Consultation document
Building Code update 2022
Protection from Fire

Issuing and amending acceptable
solutions and verification methods

2 MAY 2022

Ministry of Business, Innovation and Employment (MBIE)

Figure 5.2.1.2: Permitted small unprotected areas and fire resisting glazing

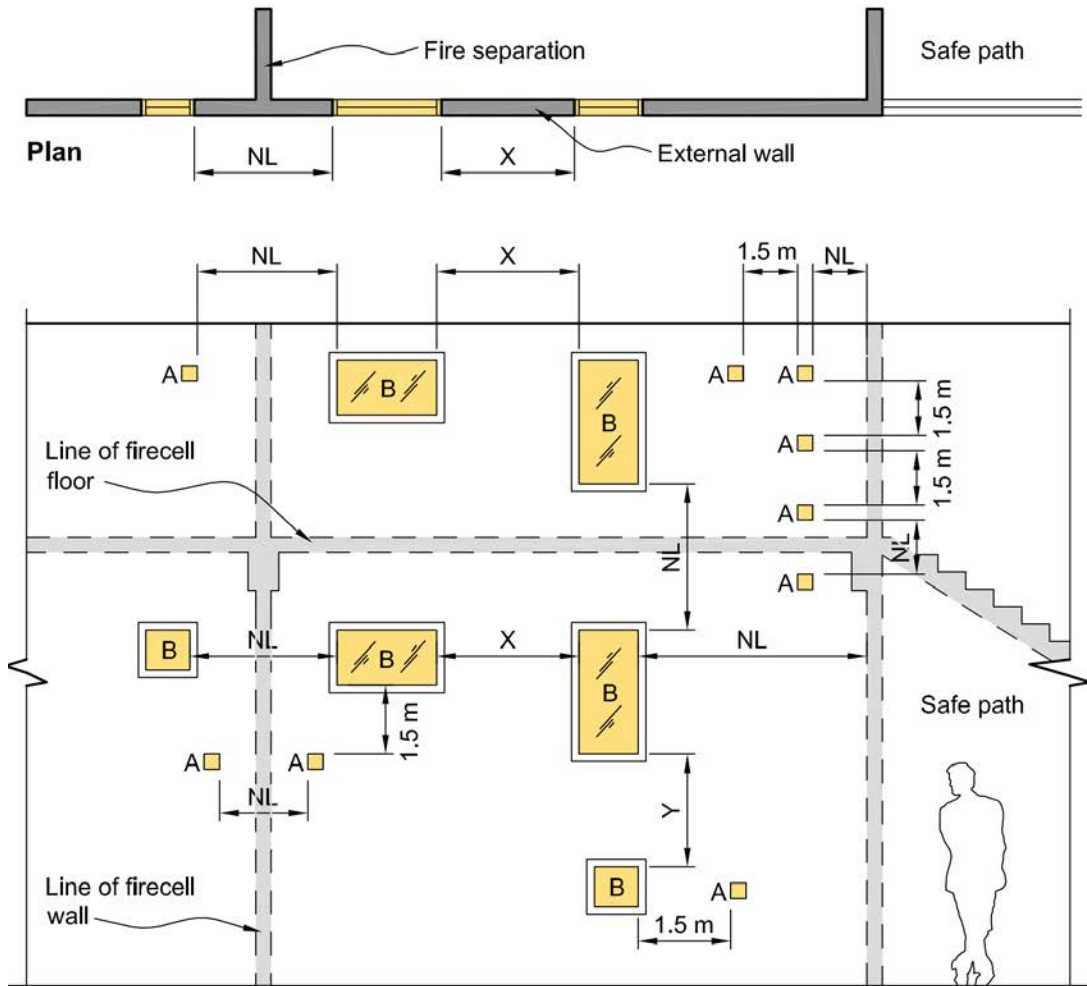
- › Specifying that fire resistance rating applies to both sides of the wall within 1.0 m of the boundary.
- › An allowance for small unprotected wall areas without fire rating (including a new figure to illustrate the requirements).
- › Specifying maximum permitted areas of fire resistant glazing.

- 5.2.1.1 If the *external wall* is required to have an *FRR*, the *external wall* is allowed to have small *unprotected areas* no greater than 0.1 m², (referred to as Type A areas), and areas of *fire resisting glazing*, (referred to as Type B areas), permitted by Table 5.2.1.1 according to the distance from the *relevant boundary*.
- 5.2.1.2 Small *unprotected areas* and *fire resisting glazing* shall be located in compliance with Figure 5.2.1.2.
- 5.2.1.3 *Fire resisting glazing* shall be rated for the *integrity* only, and the *FRR* of both the glazing and the *external wall* shall be in accordance with [Section 2.3](#).
- 5.2.1.4 Where *firecells* are protected with an automatic *fire* sprinkler system (installed as per NZS 4515 or NZS 4541), there is no limit on permitted area of the *fire resisting glazing*.

Figure 2.2 Fire safety systems throughout a building Paragraph 2.2.5

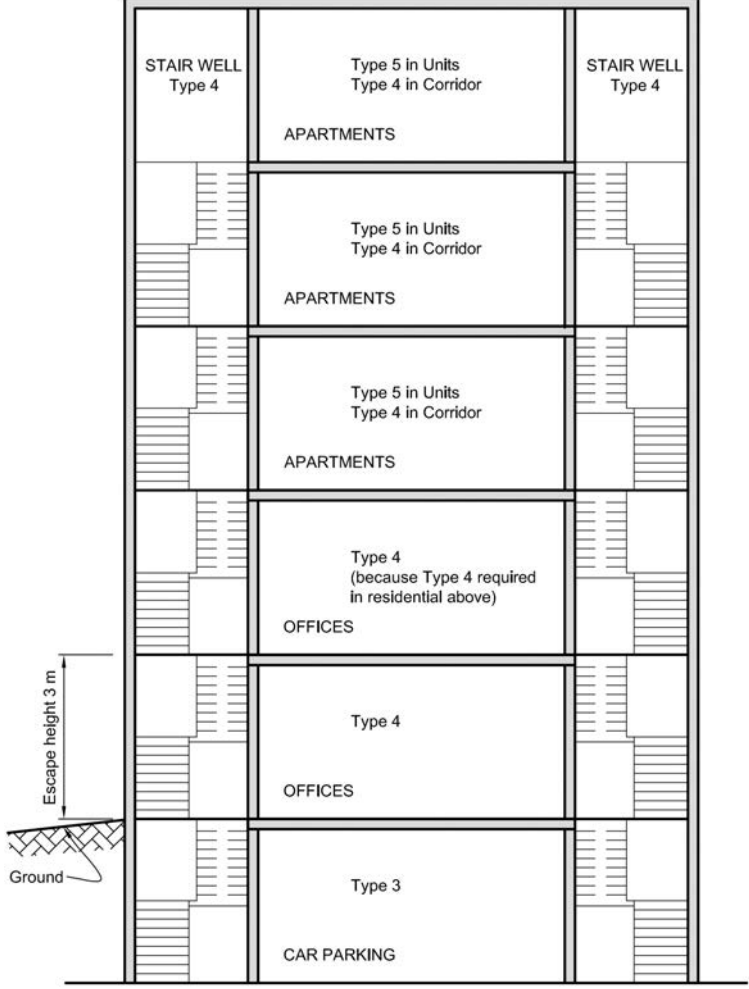
2.4.9.4. Moving the design sequence process to an informative figure

Currently C/AS2 Paragraph 2.2.3 describes a design sequence process to determine the fire safety systems for a building with multiple fire cells. Although the information is helpful to users, it is not a requirement and compliance can be demonstrated without following this process. We are proposing to remove the text of Paragraph 2.2.3 and instead describe the process in a new Figure 2.1, which will have 'informative' rather than 'normative' status. This is more appropriate for the information.

Paragraph 2.2.5 is also informative and so, for similar reasons, we are proposing to remove this.
